OHIO TURNPIKE AND
INFRASTRUCTURE COMMISSION

ADDENDUM NO. 1

PROJECT NO. 59-17-02
REPAIRS AND RESURFACING
EASTBOUND AND WESTBOUND ROADWAYS
MILEPOST 136.00 TO MILEPOST 144.10
ERIE AND LORAIN, OHIO

**OHIO TURNPIKE AND INFRASTRUCTURE COMMISSION
ADDENDUM NO. 1
PROJECT NO. 59-17-02**

ESTIMATED QUANTITIES

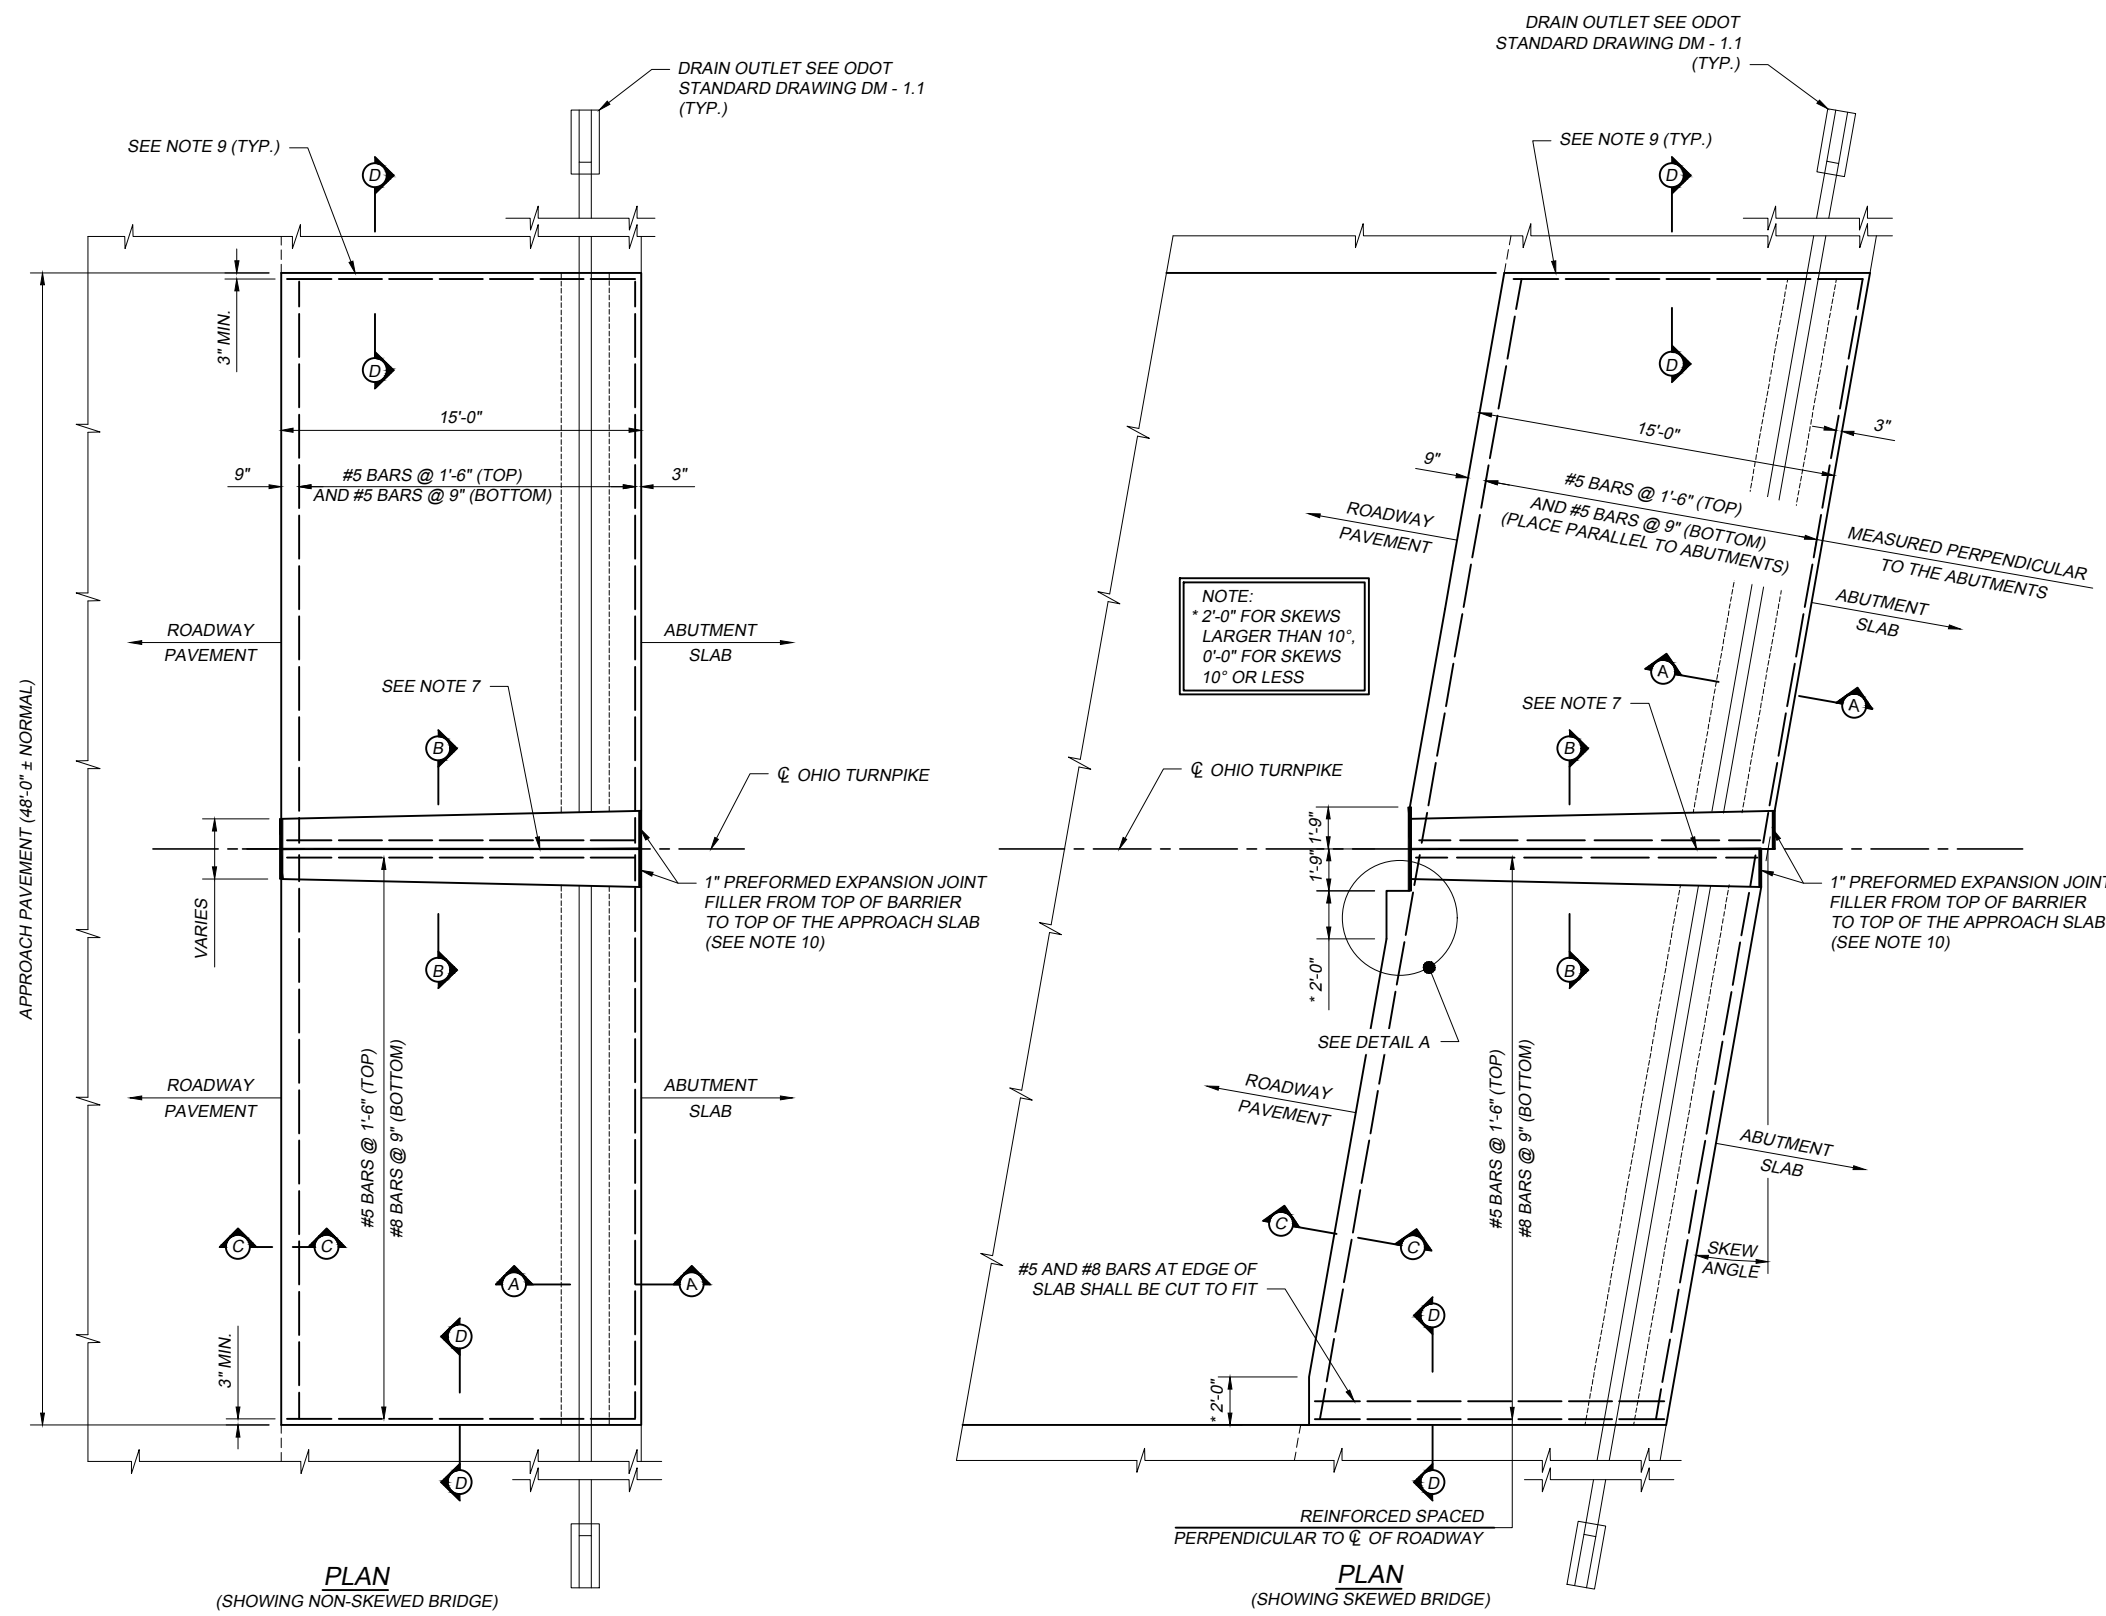
Q#1 Please clarify type of Concrete and strengths required for Item SP 526 Class C Concrete, Approach Slab, using Type 1 Cement (12"). The description of the item and all Drawings Reference Class C Concrete. SP 526 Refers you to 526.02 that requires QC2 Concrete. Also SP 526 - 2. Acceptance Of Concrete discusses Strength Level is satisfactory if it equals or exceeds the specified strength. Please verify the classification of concrete and the specified strength level you are requiring.

Q#3 Please provide the calculation sheet for the pavement planning and asphalt quantities, take off quantities from the plans do not match the bid quantities.

A#1 The reference to SP 526 - CLASS C CONCRETE, APPROACH SLAB, USING TYPE 1 CEMENT (T=12") in Plan Sheets 12 of 13 and 13 of 13 are revised through this Addendum No. 1 to specify Item 526 – REINFORCED CONCRETE APPROACH SLABS (T=12"). The revised sheet 12 of 13, 13 of 13, and ESTIMATED QUANTITIES WORKSHEET incorporated into the Contract Documents with this Addendum No. 1. Additionally, OTIC Standard Drawings AS-1, AS-2, AS-3, AS-4, and AS-5 all dated 11/28/14 are rescinded and replaced with OTIC Standard Drawing AS-1, AS-2, AS-3, AS-4, and AS-5 dated July 5, 2016. The revised standard drawings have been included with this Addendum No. 1.

A#3 The quantities for pavement planning and asphalt paving quantities have been reviewed and recalculated. The following revisions are incorporated into Plan Sheet 12 of 13, Schedule of Items and the Estimated Quantities Worksheet through this Addendum No. 1:

*ITEM 254 – PAVEMENT PLANING, ASPHALT CONCRETE (T=2") has been revised from ~~319,280~~ to **292,536**.*

*ITEM 254 – PAVEMENT PLANING, ASPHALT CONCRETE (T=3") has been revised from ~~255,760~~ to **263,506**.*

*ITEM SP 403 – ASPHALT CONCRETE LEVELING COURSE, USING CRUSHED STONE, PG 76-22(FR) has been revised from ~~3,097~~ to **2,179**.*

*ITEM SP 404 – ASPHALT CONCRETE SURFACE COURSE, USING CRUSHED STONE, PG 64-22 has been revised from ~~9,847~~ to **10,617**.*

ITEM SP 402 – ASPHALT CONCRETE INTERMEDIATE COURSE, USING CRUSHED STONE, PG 76-22(FR) has been revised from ~~12,000~~ to **12,809**.

ITEM SP 404 – ASPHALT CONCRETE SURFACE COURSE, USING CRUSHED SLAG 76-22(FR) has been revised from ~~13,587~~ to **12,683**.

ITEM SP 404A – JOINT SEALER has been revised from ~~89,222~~ to **91,900**.

ITEM 407 – NON-TRACKING TACK COAT has been revised from ~~79,450~~ to **78,450**.
